Response to Sydney North Planning Panel on Items Raised in Deferral Letter dated 26 September 2022 in Relation to Newport SLSC (PPSSNH-301 – DA2021/2173)

In a letter dated 26 September 2022, the Sydney North Planning Panel requested a response on 12 items on the above matter. A response to these items is set out herein, in turn.

Figure 1: Contiguous piles with plug piles (example from Collaroy-Narrabeen Beach private coastal protection works tender documentation)

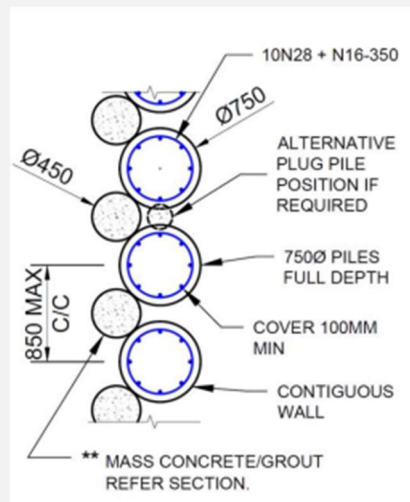
Secant piles are proposed. Contiguous piles with plug piles (see example in Figure 1) achieve a similar continuous barrier to migration of soil and may also be considered if this suits the

contractor's methodology, and this methodology satisfies the Principal's structural, coastal and geotechnical engineers. Neither option is necessarily better or worse, and they can both achieve the same outcome of a continuous barrier.

Anchor set-outs and types are a detailed design issue, and are certified by the anchoring contractor. Different lengths and types of anchors can be used at different spacings to achieve the same outcome, namely satisfactory structural analysis for the design life, and certification of the installed works for 100 years (a longer design life is typically used for anchors).

Figure 1: Contiguous piles with plug piles (example from Collaroy-Narrabeen Beach private coastal protection works tender documentation)

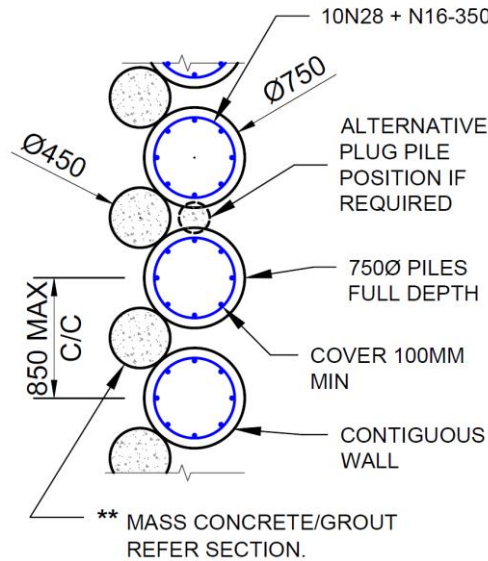
2.6 Item 6 – Type of Piling

Secant piles are proposed. Contiguous piles with plug piles (see example in Figure 1) achieve a similar continuous barrier to migration of soil and may also be considered if this suits the contractor's methodology, and this methodology satisfies the Principal's structural, coastal and geotechnical engineers. Neither option is necessarily better or worse, and they can both achieve the same outcome of a continuous barrier.

Anchor setouts and types are a detailed design issue, and are certified by the anchoring contractor. Different lengths and types of anchors can be used at different spacings to achieve the same outcome, namely satisfactory structural analysis for the design life, and certification of the installed works for 100 years (a longer design life is typically used for anchors).
